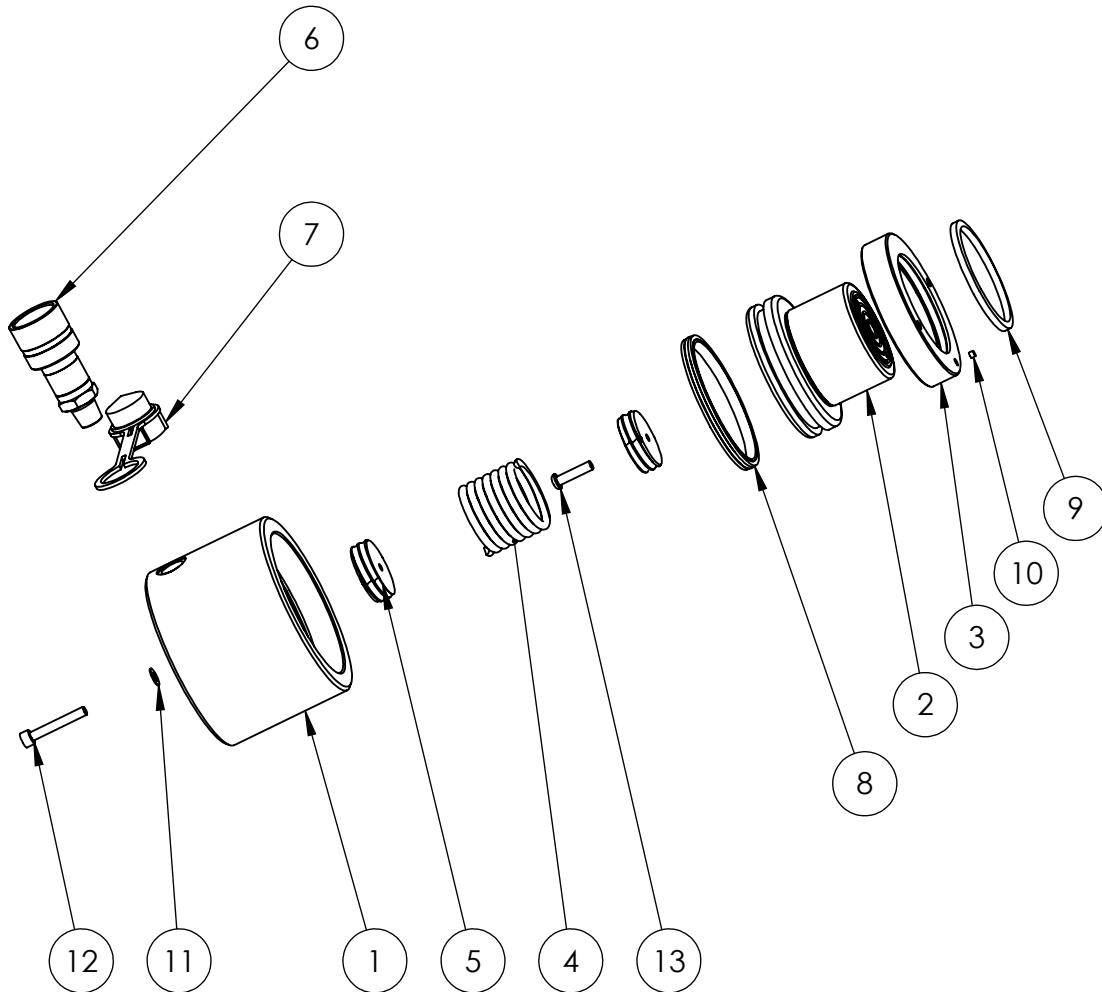
1. ITEMS MARKED X ARE AVAILABLE IN SERVICE KIT HLS50TP1-K ONLY
2. OBSOLETE PARTS. REPLACE AS A PAIR WITH PRC095FB002 AND SRC070SJ003. ALSO ORDER REVISED SERVICE KIT HLS50TP2-K INSTEAD OF HLS50TP1-K
3. IF SPRING IS REPLACED, INSERTS SHOULD ALSO BE REPLACED.

1. ITEMS MARKED X ARE AVAILABLE IN SERVICE KIT HLS50TP2-K ONLY
2. IF SPRING IS REPLACED, INSERTS SHOULD ALSO BE REPLACED.
